# memorandum

T10/07-361r1

To	From	Subject	Date
INCITS T10 Committee	Curtis Ballard, HP Michael Banther, HP	SSC-3 Out of Band Encryption Key Management	15 September, 2007

Figure 8 — UML example of SCSI target device and physical device

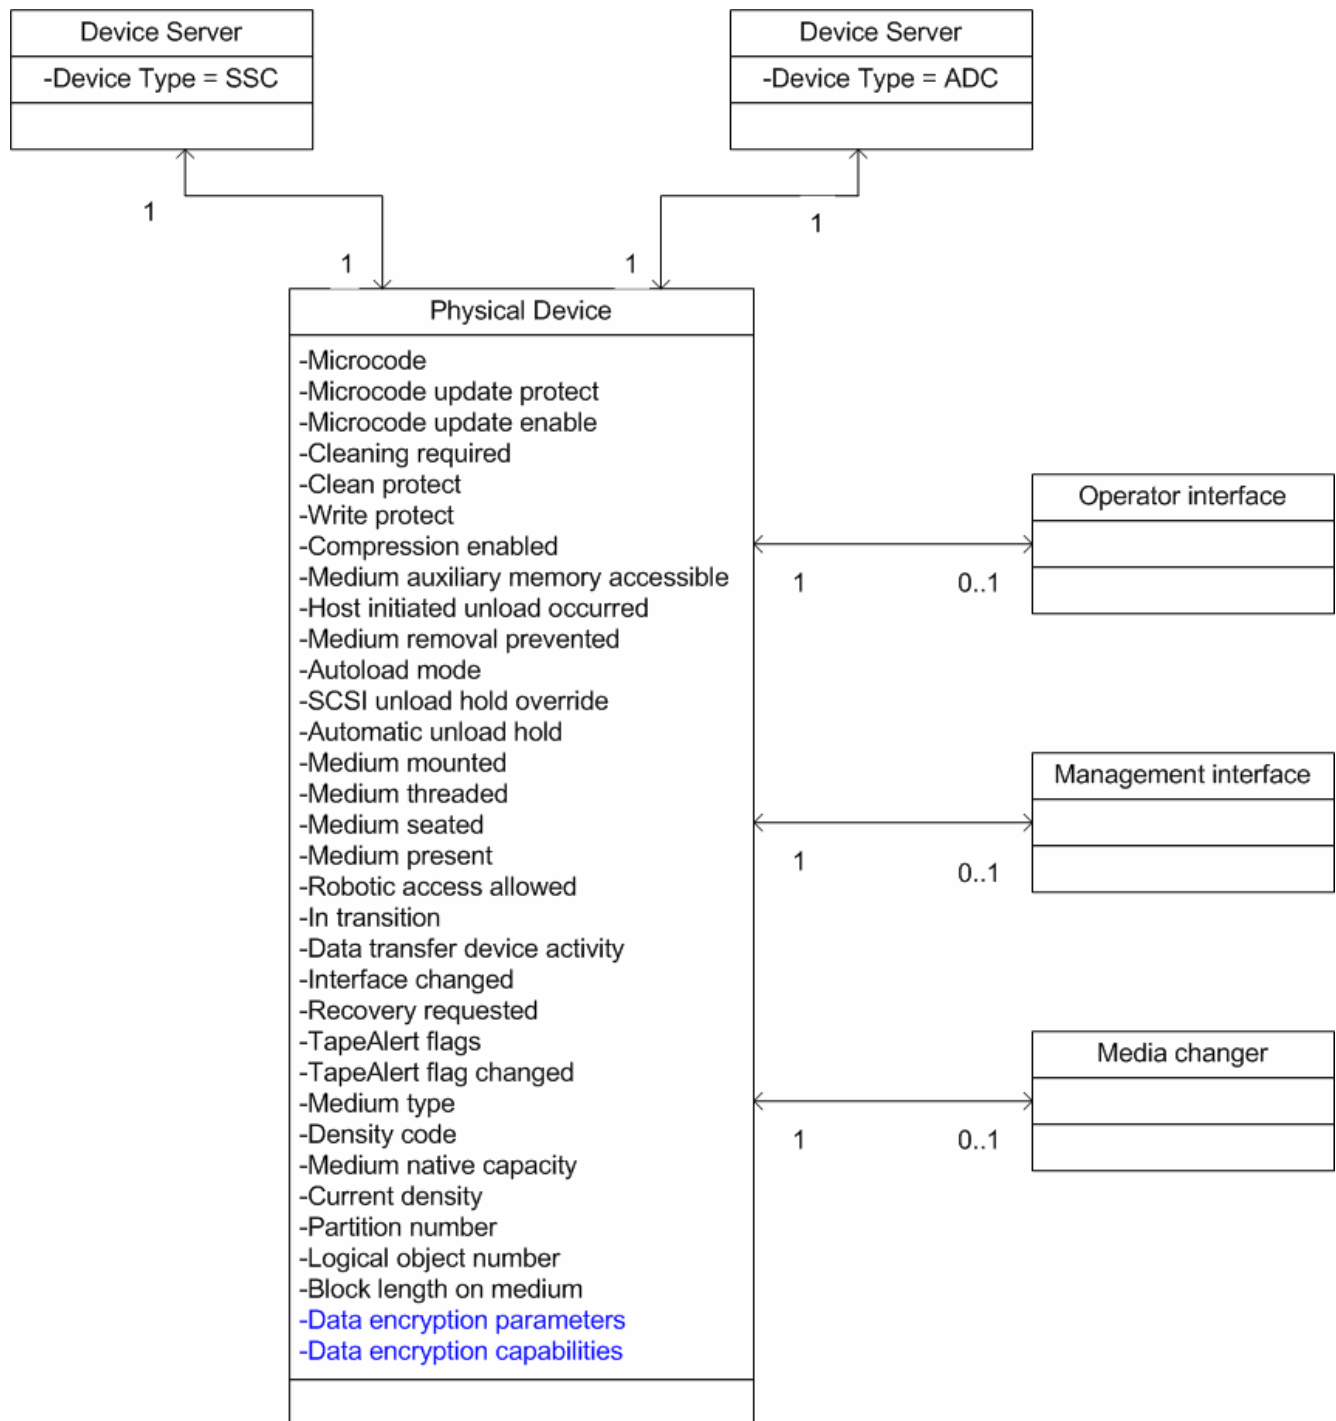
Add data encryption parameters and data encryption capabilities to list of items in physical device in figure 8.
